PUBLIC HEARING MEMORANDUM

SUBJECT: **Petition #304-21** Request to Rezone 11 Florence Street SUNRISE DEVELOPMENT, INC petition to rezone 11 Florence Street, known as section 82 Block 04 Lot 49 from MULTI RESIDENCE 1 to BUSINESS USE 2.

Petition #305-21 to allow elderly housing with services, to allow a four-story building, to allow a retaining wall greater than 4' in height within a setback, to allow free-standing signs, to allow parking in the front setback, to reduce the required parking stall length, to waiver perimeter screening requirements and to waive one foot candle lighting at 11 Florence Street, Ward 8, Newton Centre, on land known as Section 82 Block 04 Lots 47 and 49, containing approximately 82,945 sq. ft. of land in a district zoned BU2 (318 Boylston Street) and MR1 (11 Florence Street, to be rezoned to BU2). Ref: Sec. 7.3.3, 7.4, 4.4.1, 6.2.10, 4.1.2.B.1, 4.1.2.B.3, 4.1.3, 5.4.2.B, 5.1.8.A.1, 5.1.13, 5.1.9, 5.1.8.B.2, 5.1.10.A.1, 5.13, 5.2.13 of the City of Newton Rev Zoning Ord, 2017.

Re: Special Permit – 11 Florence Street Sunrise of Chestnut Hill

Proposed Site Plan

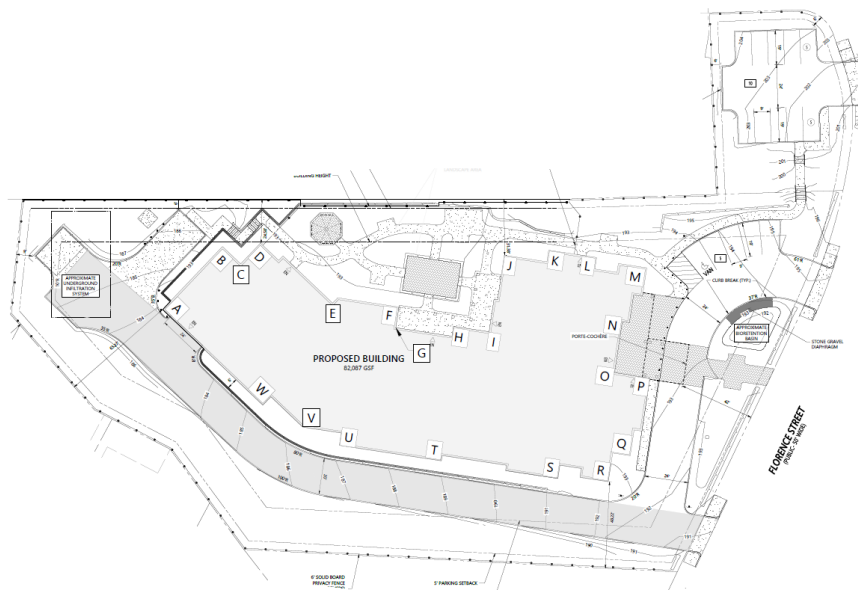
There is a proposed retaining wall to the rear of the building and a retaining wall to construct the stairs at the outer walkway of the site. The plans submitted at zoning review indicated a portion of a retaining wall exceeding four feet in height may be within the side setback, as such the relief was identified and applied for. The petitioner since stated that the portion of the wall which exceeds four feet in height is outside of the setback and anticipates withdrawing this relief. The petitioner should confirm and provide the Planning Department with the measurements of the wall inside and outside of the setback to confirm the relief is no longer needed.

The petitioner also requires relief for parking within the front and side setbacks for the surface parking stalls. Four of the five stalls in the front of the building are within the 24-foot setback and most of the parking stalls in the ten-stall surface parking facility are in either the 24-foot front or side setbacks. The petitioner should submit a plan showing the setbacks from Parcel A to better determine how many parking stalls are within the setbacks.
